CALL NO. 314
CONTRACT ID NO. 212153
ADDENDUM # 1

Subject: Hancock County, FD05 046 0060 000-003 Letting June 25, 2021

- (1) Revised Summary Sheet Page 9 of 68
- (2) Revised Delete Special Note Pages 17-19 of 68
- (3) Revised Typical Section Sheets Pages 49-51 of 68
- (4) Added Transverse Joint Detail Sheet Page 51(a) of 68
- (5) Revised Proposal Bid Items Page 68 of 68

Hancock County TYPICAL SECTION FD05 046 0060 000-003 MP's 0.000 to 1.76

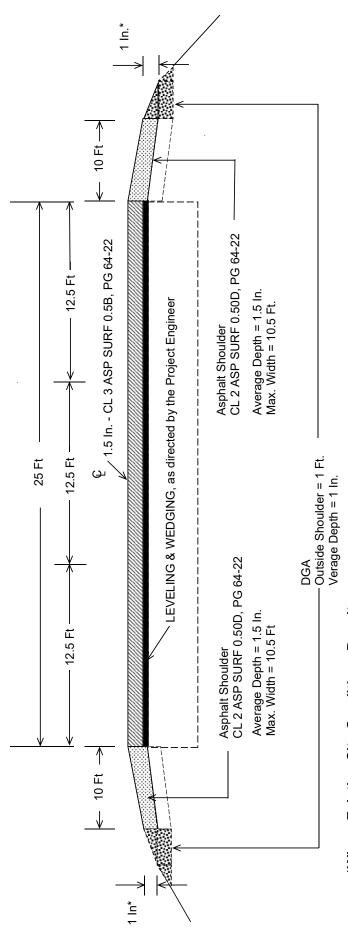
Contractor is to place DGA base beyond paved shoulder one foot wide averaging one inch in depth.

Hancock County TYPICAL SECTION FD05 046 0060 000-003 MP's 1.760 to 2.275

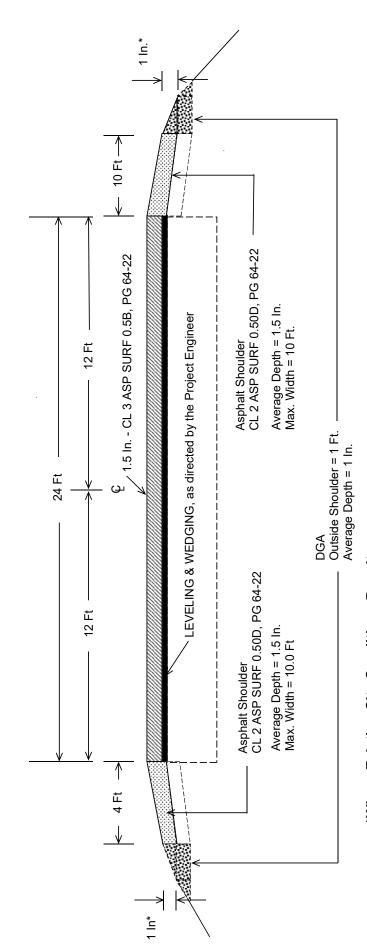
*Where Site conditions permit place DGA base at edge of paved shoulder for a width of 1 foot and an average depth of 1.5 inches Centerline Rumbles MP's 0.000 to 1.924

TRANSVERSE JOINT DETAIL

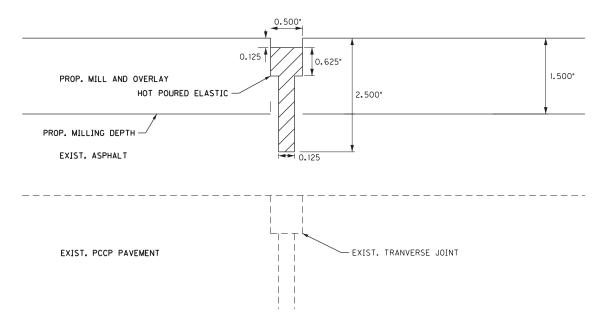
EXISTING TRANSVERSE JOINTS WILL BE FIELD LOCATED AND MARKED BY THE ENGINEER. THE LOCATIONS BY THE ENGINEER WILL BE BASED ON VISUAL INSPECTION OF THOSE JOINTS THAT HAVE REFLECTED UP THROUGH THE ASPHALT AND MEASUREMENTS FOR THOSE THAT ARE NOT APPARENT. ENGINEER WILL MARK THE JOINTS ONE TIME. THE CONTRACTOR IS REQUIRED TO SURVEY THE MARKED LOCATIONS AND THEN RE-ESTABLISH THE LOCATIONS AFTER THE NEW ASPHALT IS PLACED. THE CONTRACTOR SHALL PROVIDE BEFORE AND AFTER SURVEY DATA OF THE LOCATIONS. THIS SURVEYING AND MARKING SHALL BE INCIDENTAL TO BID ITEM "STAKING".

THE LOCATION OF THE PROPOSED JOINT, SHOWN ABOVE, SHALL BE MADE DIRECTLY ABOVE THE EXISTING JOINT AS MARKED BY THE ENGINEER. ALL EXISTING JOINTS MARKED BY THE ENGINEER SHALL HAVE A JOINT INSTALLED ABOVE THEM. THE JOINT SHALL BE SAWED, CLEANED, AND SEALED AFTER THE NEW ASPHALT IS PLACED, BUT PRIOR TO FINAL STRIPING.

SAWCUT JOINTS SHALL EXTEND THE FULL WIDTH OF THE LANES PLUS TWO FEET BEYOND THE EDGE OF LANES. THE CUT JOINTS SHALL BE THOROUGHLY CLEANED AND DRIED PRIOR TO APPLICATION OF SEALING MATERIAL. DRY SAWED JOINTS SHALL BE CLEANED WITH COMPRESSED AIR. WET SAWED JOINTS SHALL BE CLEANED WITH WATER JET AND BLOWN DRY WITH COMPRESSED AIR. THE JOINT SEALANT MATERIAL SHALL BE HOT POURED ELASTIC.

ALL WORK AND MATERIALS NECESSARY TO COMPLETE THE SAWCUT, CLEANING, AND SEALING OF TRANSVERSE JOINTS SHALL BE INCIDENTAL TO BID ITEM "SAW-CLEAN-RESEAL TVERSE JOINT".
